4. South East Vale Sub-Area

East of Sutton Courtenay (8.83 ha)

Milton Heights, Milton Parish west of the A34 (15.81 25 ha)

Valley Park, Harwell and Milton Parishes east of the A34 adjoining Didcot Town (180.73 186 ha)

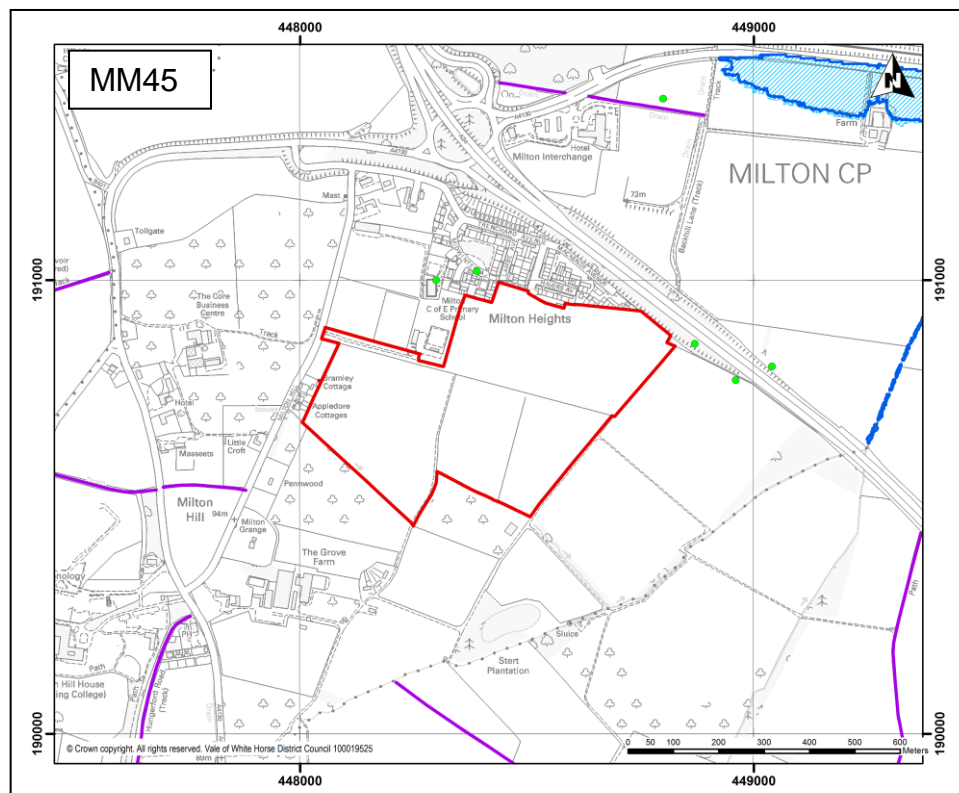
- **UPGRADE THE SEWER NETWORK.**

- Investigate access arrangements. **ACCESS FROM FRILSHAM STREET IS PREFERRED BUT** access from **B4016 may be possible**. Contribution and/or onsite mitigation towards countryside access will be sought from the development.
- Contribute towards future strategic infrastructure improvements to Abingdon-on-Thames and any necessary mitigation measures identified through the site Transport Assessment.
- Relocate existing bus stops at High Street Garage closer to the junction of the High Street with Frilsham Street, along

- Contribute towards **EDUCATION PROVISION** increasing the capacity of the primary school in Sutton Courtenay and expansion of secondary school capacity in Didcot **EXPANDING SECONDARY SCHOOL CAPACITY IN ABINGDON-ON-THAMES.**

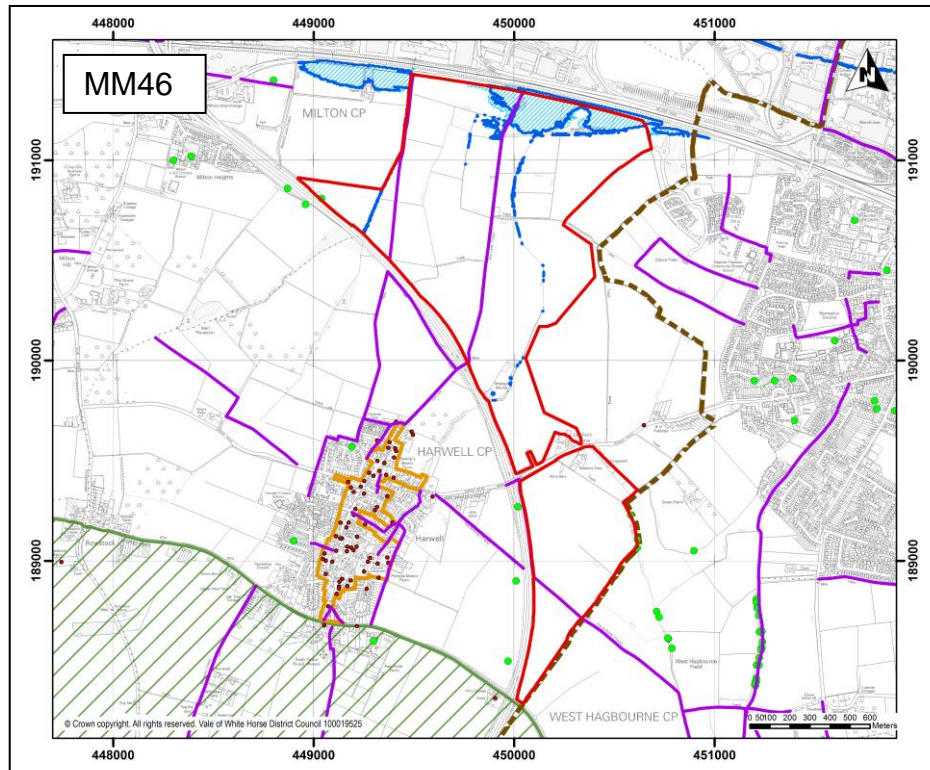
- Contribute towards increasing the capacity of St. Blaise Primary School. Land for the expansion of the school will need to be identified.
- Contribute towards increasing **TO A NEW** secondary school capacity in **AT GREAT WESTERN PARK OR** Didcot **NORTH EAST.**
- Provide public open space and recreational facilities in accordance with the Vale's emerging playing pitch strategy.
- Contribute towards additional community facilities and services.

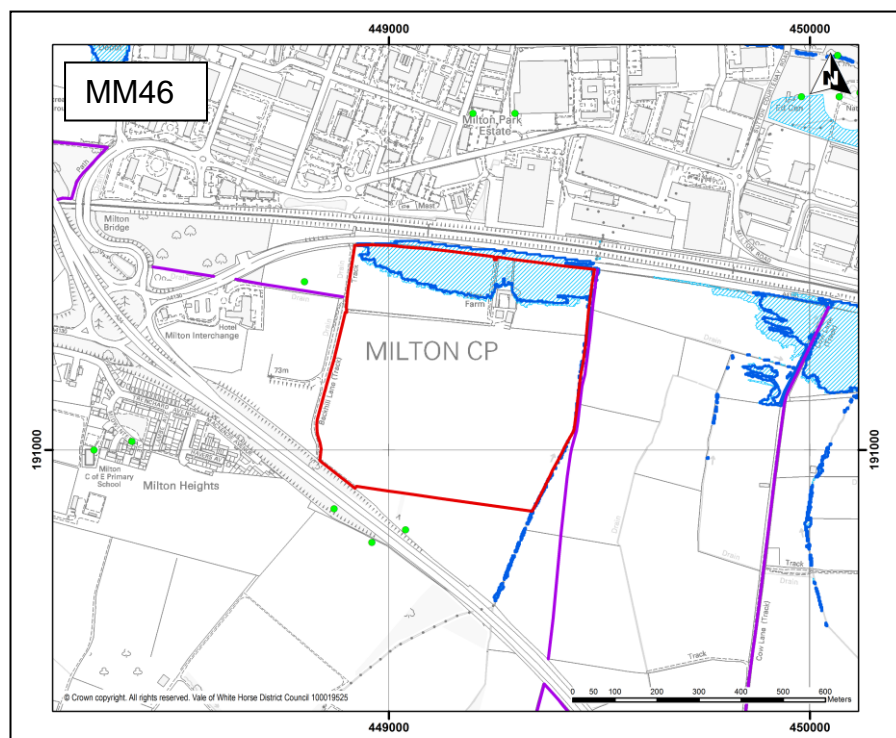
- ~~Two new 'two form entry' primary schools will be required to accommodate growth on Valley Park and North West Valley Park site allocations; 2.22 ha of land is required for each school. One school may need to be 'three form entry' at least during peak years and will require a site of 3.01 ha. The schools should be provided across this site and the adjacent North West Valley Park site, with appropriate pro-rata~~

~~contributions.~~ **THREE NEW PRIMARY SCHOOLS ARE REQUIRED IN RESPECT OF THE TWO SITES. ONE NEW PRIMARY SCHOOL WILL BE REQUIRED ON THE NORTH WEST VALLEY PARK SITE AND TWO OTHER NEW PRIMARY SCHOOLS WILL BE REQUIRED ON THE VALLEY PARK SITE.**

- Contribute **TO A NEW** ~~towards enlargement of the~~ secondary school at Great Western Park **OR** Didcot **NORTH EAST.**
- Provide land (1.6 ha) and contribute towards a 100 pupil special needs school.

North West of Valley Park (38.58 33.25 ha)

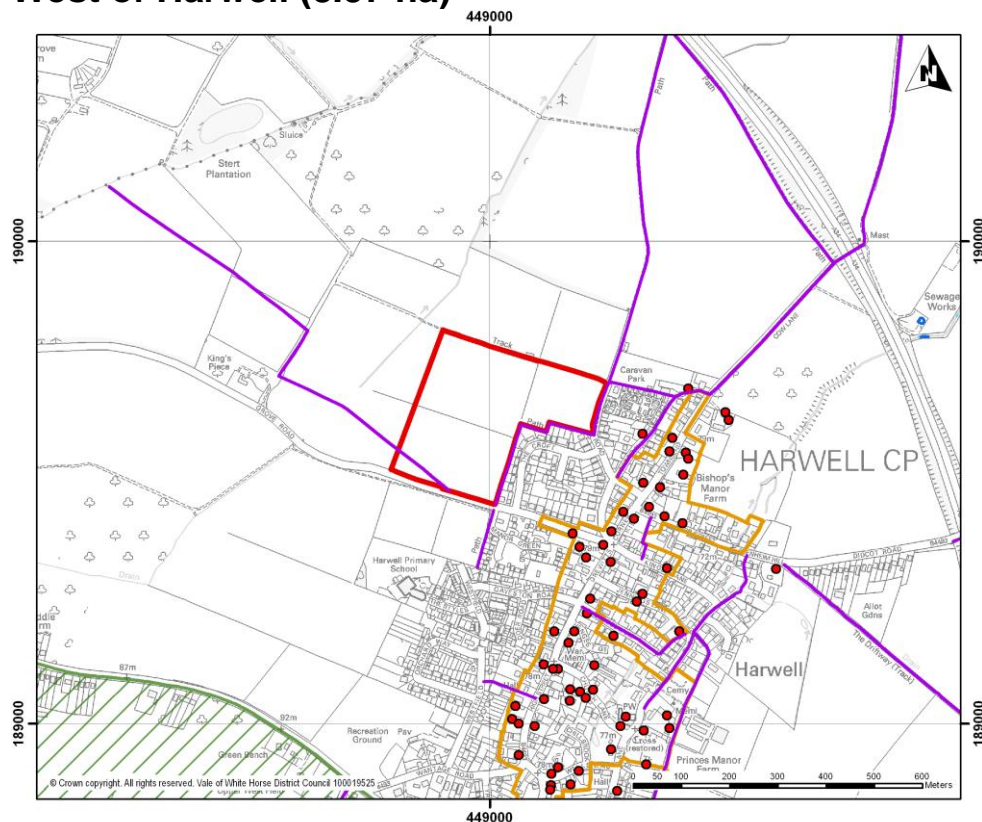
- Create east-west movements through this site in the direction of Didcot town to link with access roads in Valley Park and Great Western Park.
- **PROVIDE LAND FOR WIDENING OF THE A4130.**

- **SHOULD ACCESS TO THE SITE BE PROVIDED FROM THE A4130 VIA MILTON INTERCHANGE SERVICES, ANY NECESSARY IMPROVEMENTS WOULD BE FACILITATED BY PROMOTERS/DEVELOPERS OF THE ALLOCATION.**

THREE NEW PRIMARY SCHOOLS ARE REQUIRED IN RESPECT OF THE TWO SITES. ONE NEW PRIMARY SCHOOL WILL BE REQUIRED ON THE NORTH WEST VALLEY PARK SITE AND TWO OTHER NEW PRIMARY SCHOOLS WILL BE REQUIRED ON THE VALLEY PARK SITE.

- Provide land (1.6 ha) and contribute towards a 100 pupil special needs school.
- **CONTRIBUTE TO A NEW SECONDARY SCHOOL AT GREAT WESTERN PARK OR DIDCOT NORTH EAST.**
- Provide a neighbourhood centre of approximately 500

East of Harwell Campus (Harwell and Chilton Parishes) (61.74 ha)

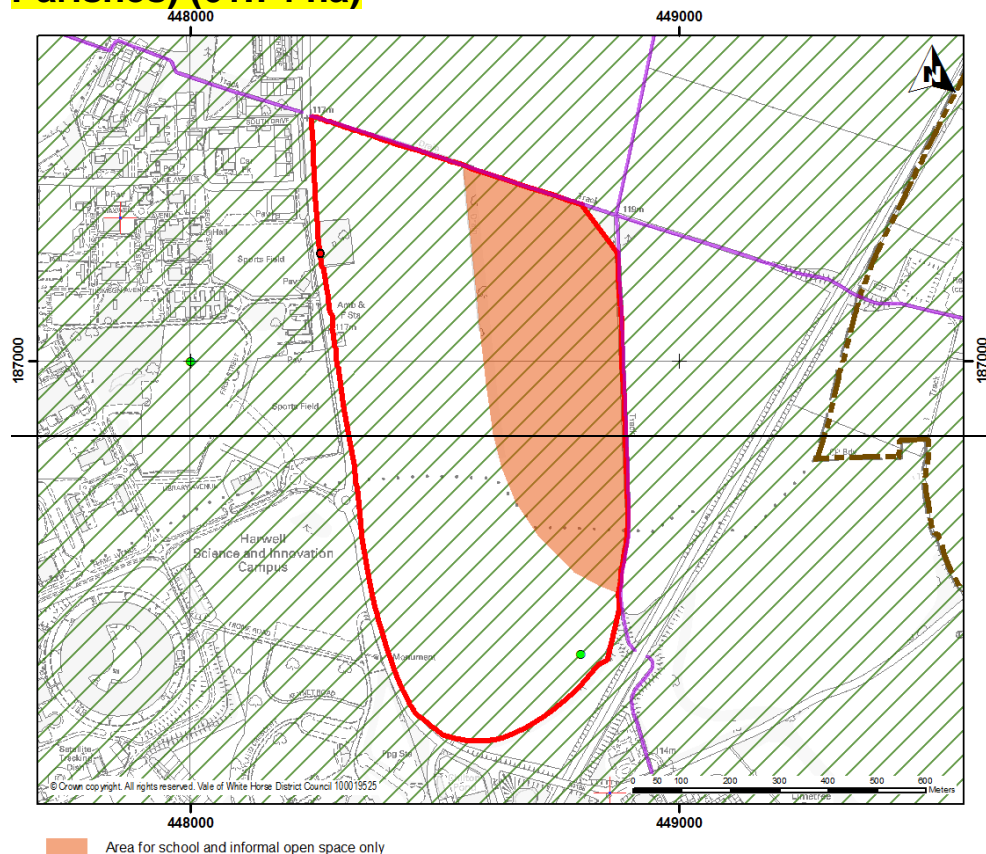
MM54

North of Harwell Campus (18.93 ha)

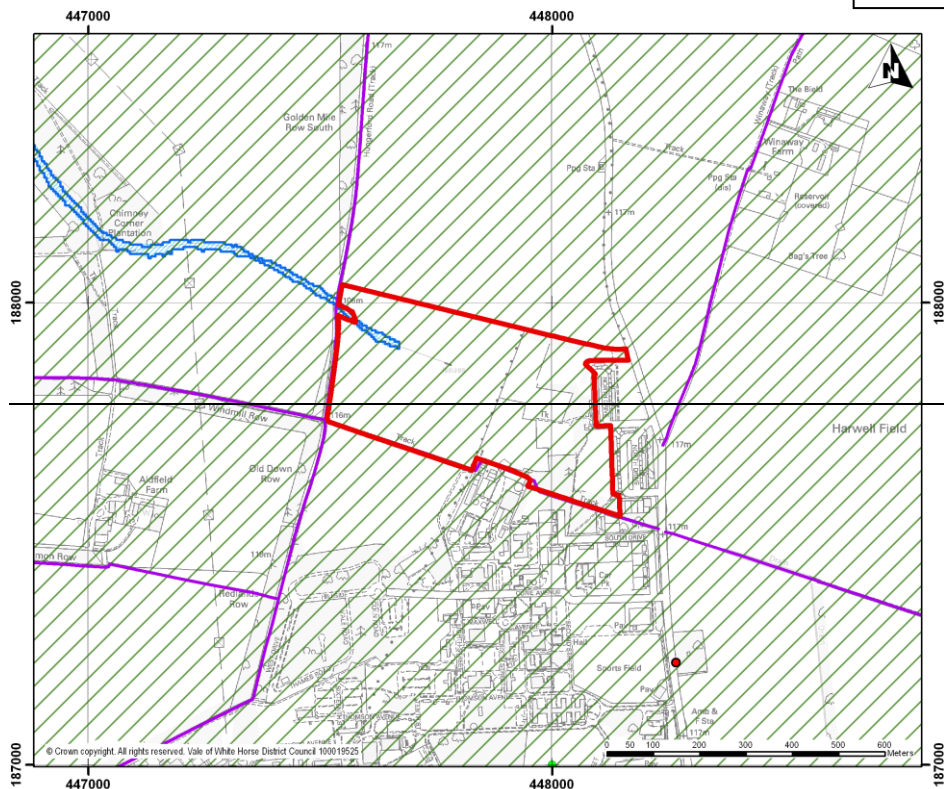
MM55

~~Key objectives:~~

Monks Farm, Grove (56.7 60.63 ha)

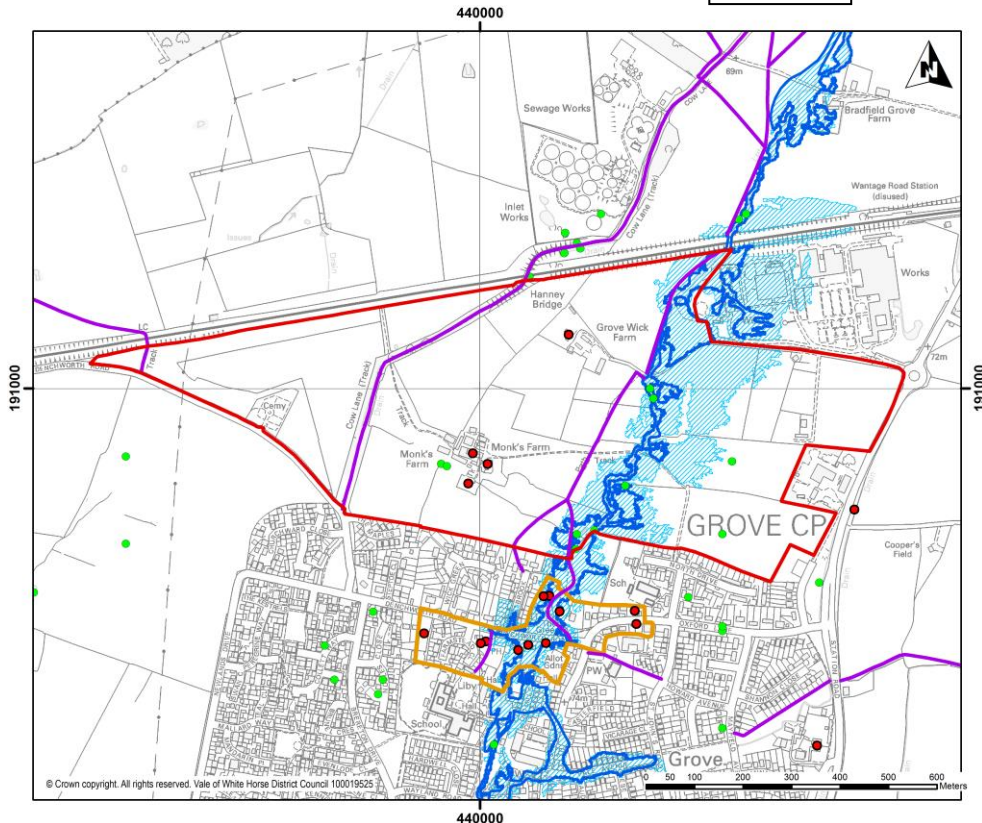
MM56

- Contribute towards expanding Grove Church of England Primary School **OR PROVIDE A NEW SCHOOL WITHIN THE MONKS FARM SITE.**
- Contribute towards a new secondary school at Grove Airfield.
